## WIX 46907 Air Filter Product Update

## PRODUCT UPDATE

**Updated 46907**

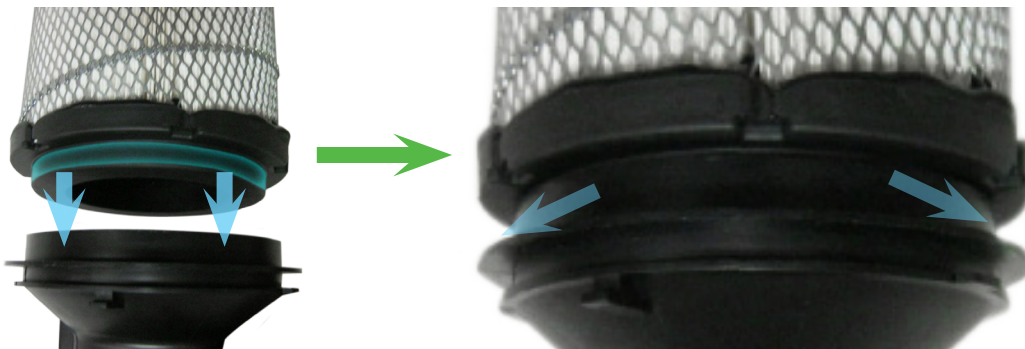
A recent update has taken place for the 46907 with a notable change in the sealing design.

*The previous seal is similar to the original equipment service (OES) that seals over the outside of the flow tube.*

*The updated design seals into the inside of the flow tube. The updated seal is more robust and easier to install/remove.*

The update is part of an ongoing change. Principal applications included in this update are Chevrolet/GMC C4500 and C5500 trucks. It should be noted that both the previous and new 46907 are fully interchangeable and suitable for use on all recommended applications.
